REMARKS

ANNOTATED MARKED-UP DRAWINGS

Fig. 13a

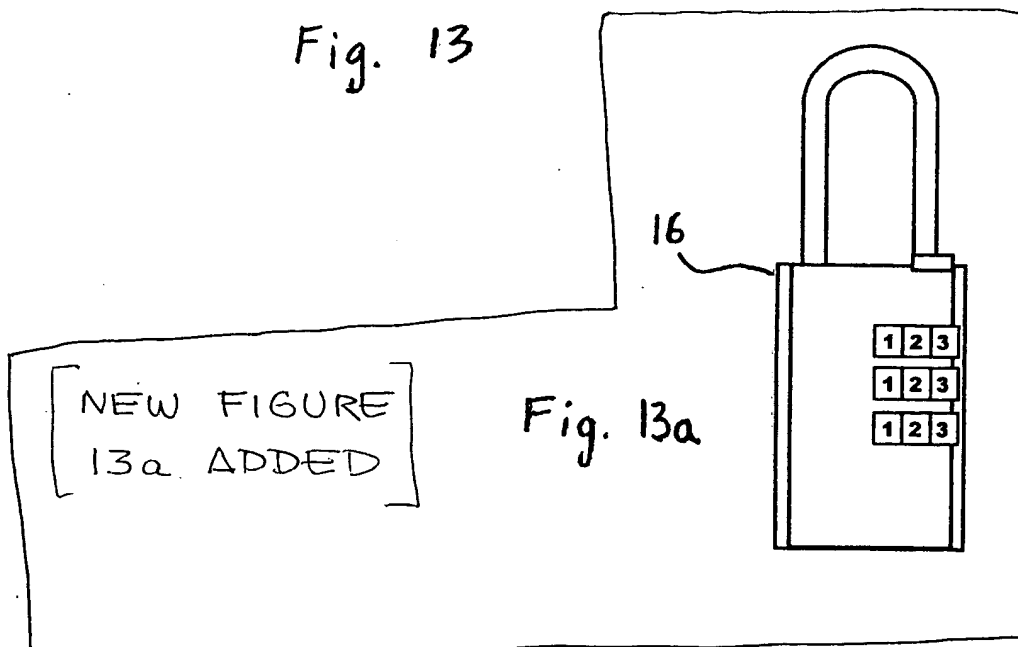
The Examiner has objected to the drawings under 37 C.F.R. § 1.83(a) on the grounds that the submitted drawings did not show every feature of the invention specified in the claims. Corrected drawings are included herewith which show the means to lock the hasp bar having a code-operated combination locking mechanism. In particular, the corrected drawings include a new figure, Fig. 13a.

[NEW FIGURE
13a ADDED]
